## MVE Freezer Number Labels

# Discharge Device Relief Valves

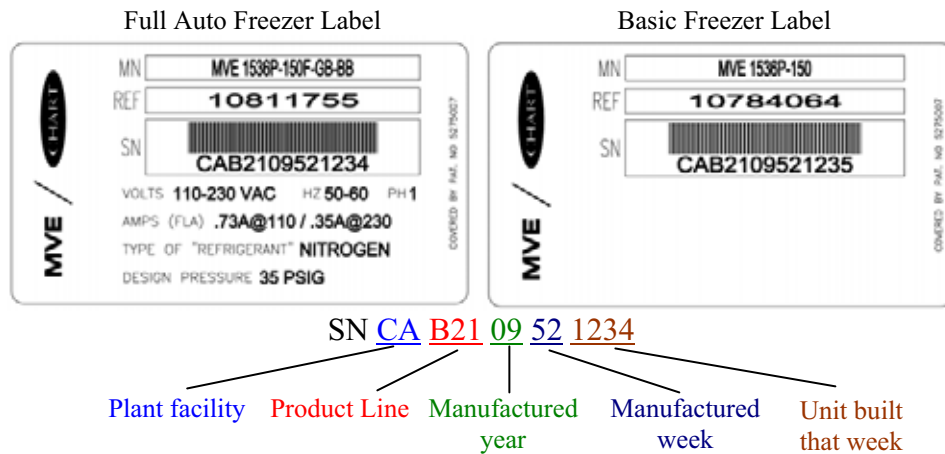
**DETAILS:** In April 2009, MVE Freezers will begin using a new serial number scheme. The new UPC bar-coded serial number labels are shown and explained below. The manufactured year and week can be determined from this serial number scheme. Remember, warranties are based on the ship date and not on the manufacture date. Although they are often similar, please contact Customer or Technical Service for any questions regarding warranty dates or this new label.

The above sample serial number would represent the 1234<sup>th</sup> MVE Freezer manufactured at our Canton facility in the 52<sup>nd</sup> week of 2009.

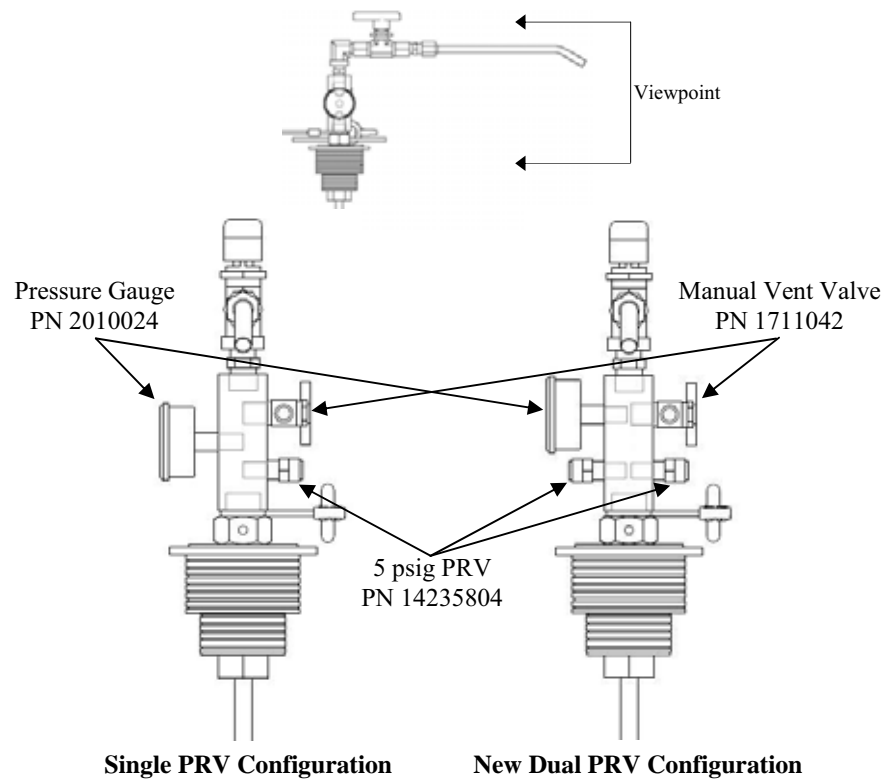
**DETAILS:** In May 2009, all MVE manual liquid discharge devices will undergo a design change and will be equipped with a second 5 psig (0,34 bar) primary relief valve (PRV). To accommodate this redundant PRV, the pressure gauge is being shifted up directly across from the manual vent valve. This design enhancement will increase the volume of possible relief valve flow. The second relief valve will have the same threads and pressure rating as the current one; however, the part number for the discharge device relief valves will change. Both designs will use the same service relief valves.

Manual Discharge Device	Previous Part Number	New Part Number
Single relief valve design	1810112	14235804
Dual relief valve design	N/A	14235804 x 2
